7 July 1961

TO
FROMSubject: ECP LAC-112 - "INSTALL LARGER RELAY & CIRCUIT
BREAKER BOX"

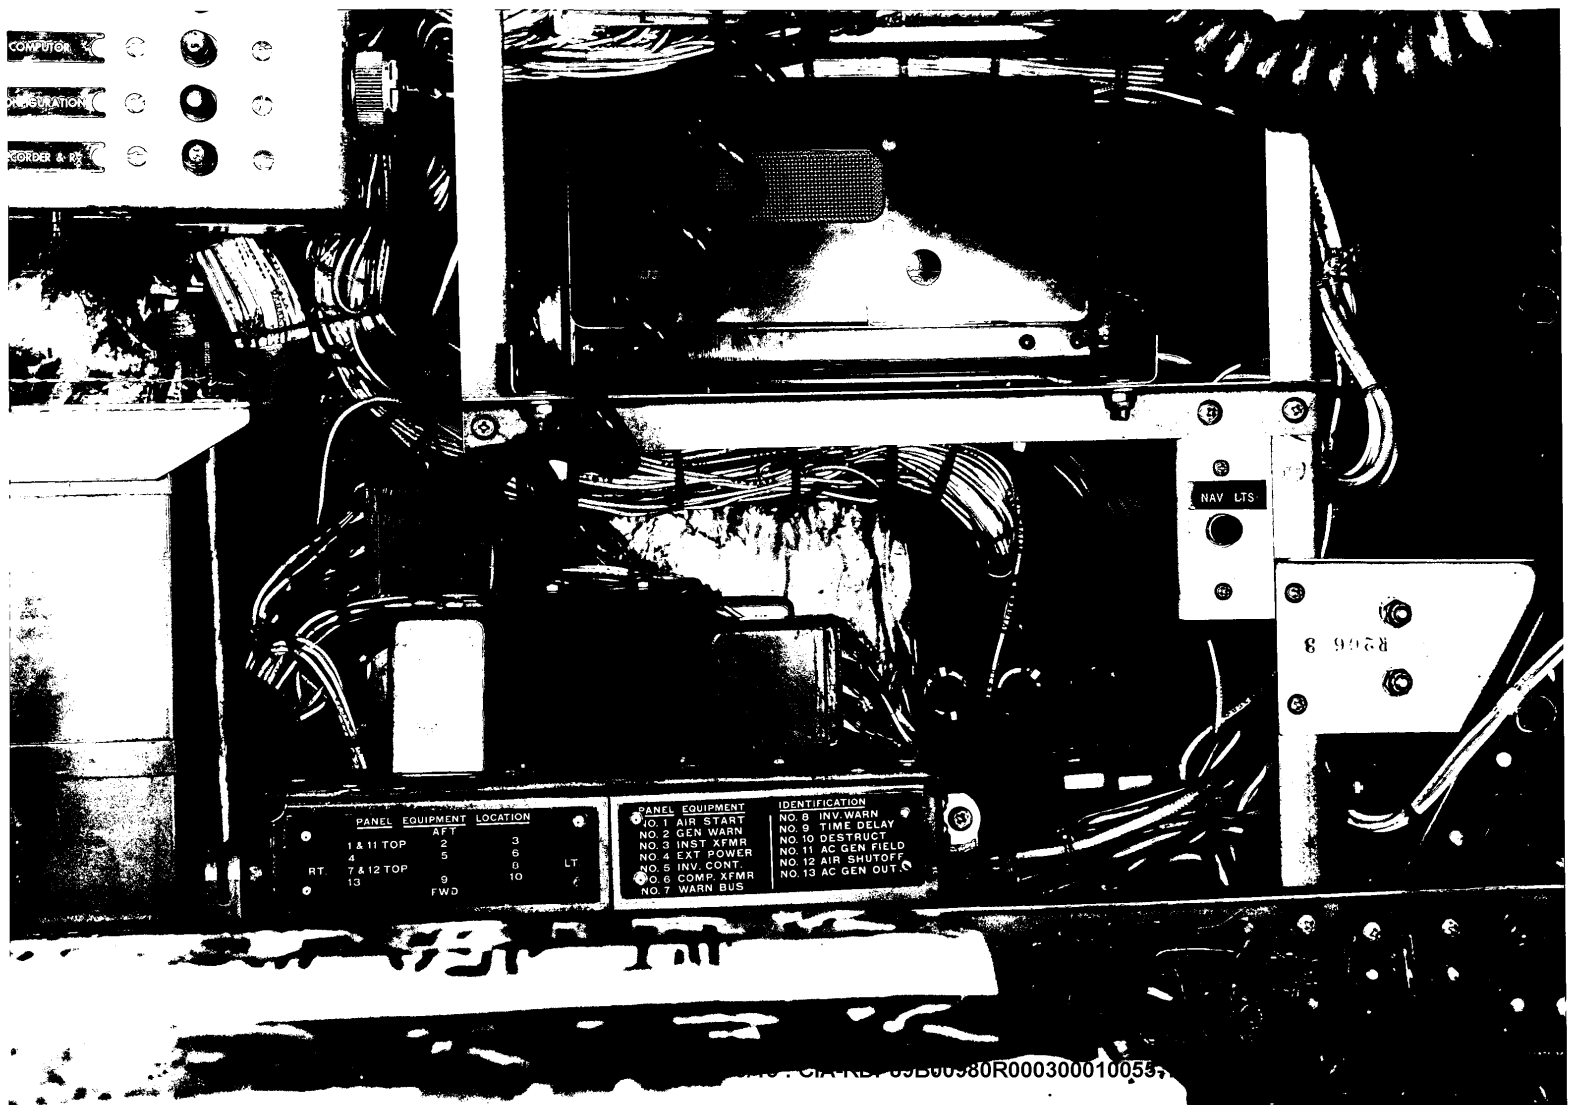
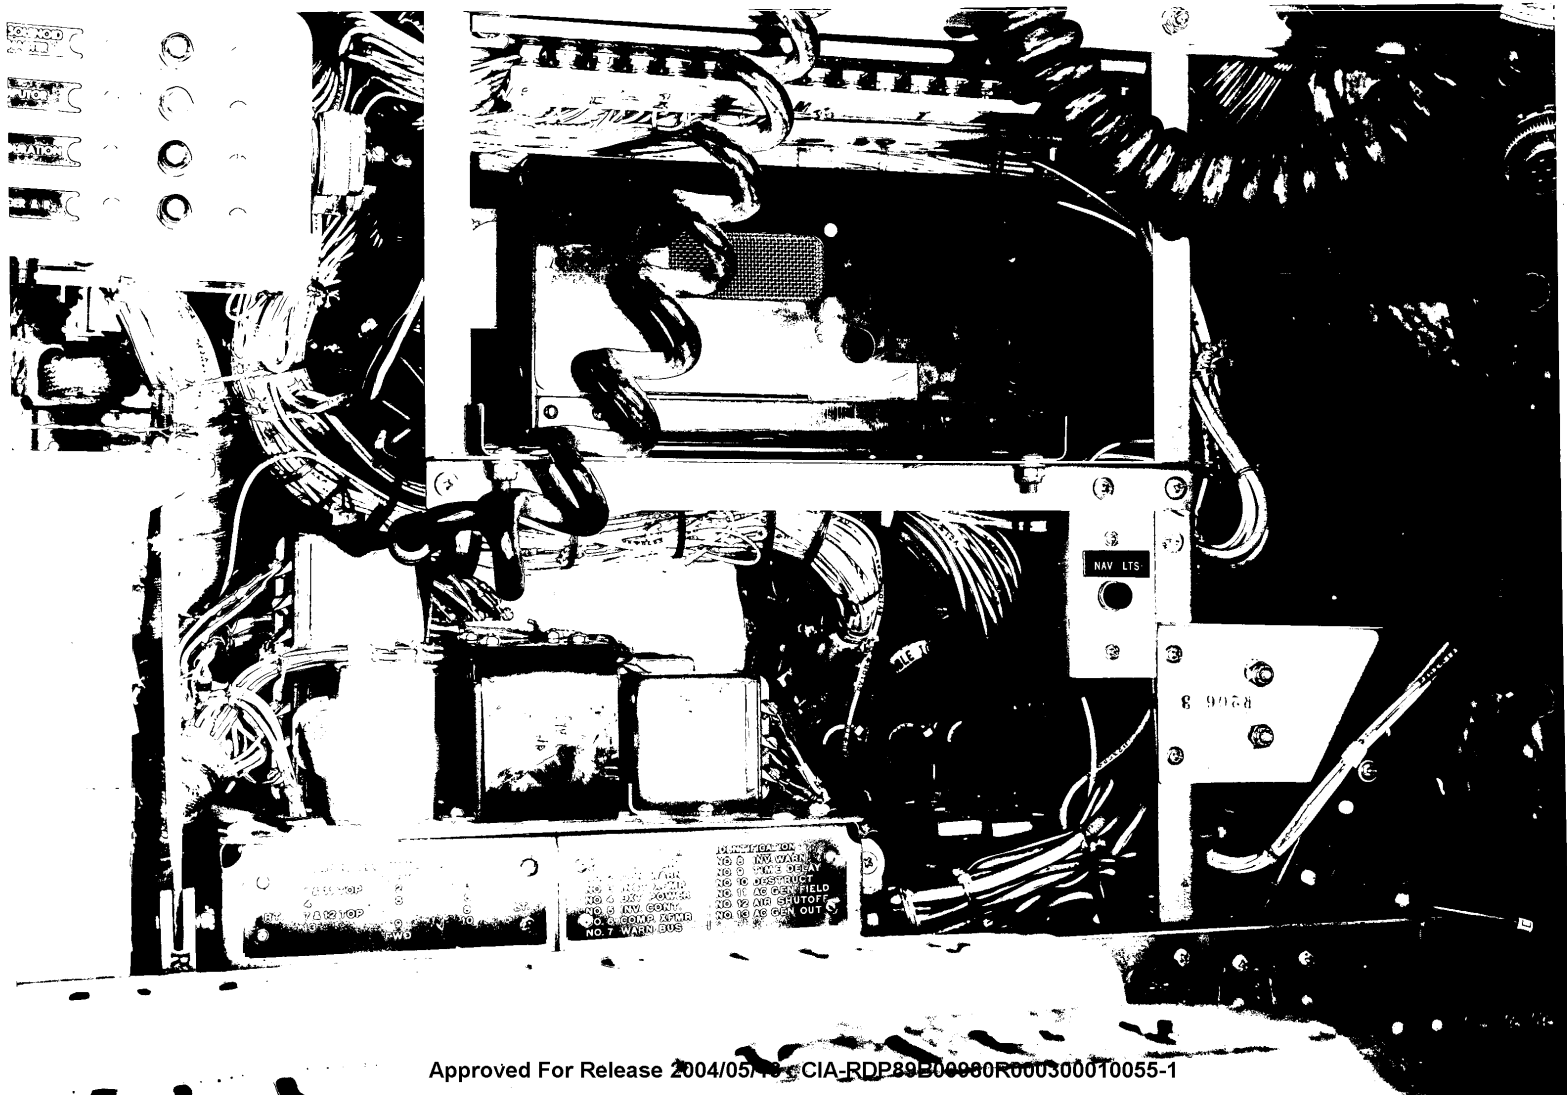
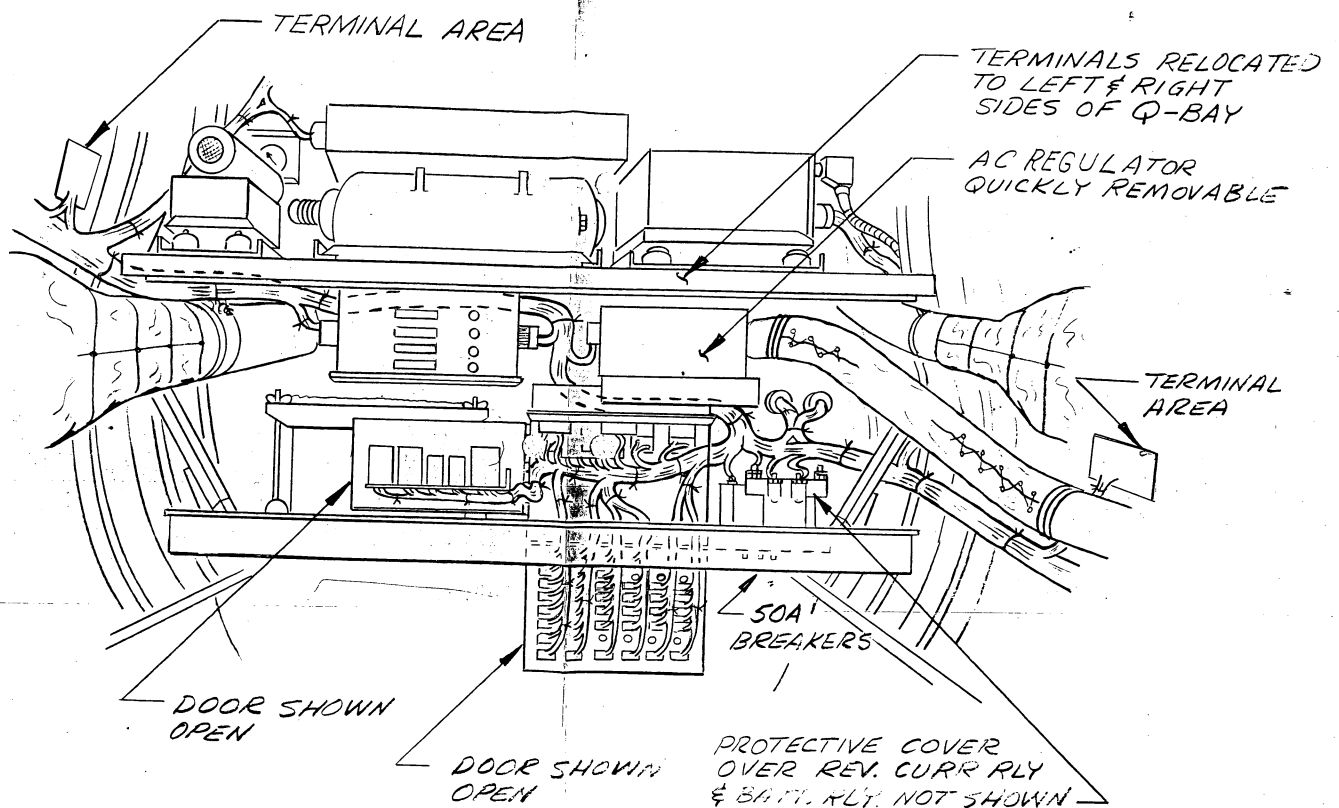
The mock-up in the first airplane has proven the new design to provide the following advantages.

1. Greatly reduces the number of wires in the radio rack by relocating the E-1 terminal strips from the rack to locations on both sides of the Q-bay - forward of the radio rack. This also provides better access to the terminal strips and shorter wire runs.

5. The battery relay has been moved from the present undesirable location adjacent to the battery and under control cables to a position on an insulated panel adjacent to the reverse current relay. This arrangement affords improved accessibility and protection from damage by use of a removable plastic cover.

6. Removing the supporting structure for the AC voltage regulator and installing the regulator on top of the new junction box by use of a quickly removable plate, provides improved access to the equipment on bulkhead 319 in this area.

The enclosed photos delineate the present configuration and the drawings are of the new configuration.
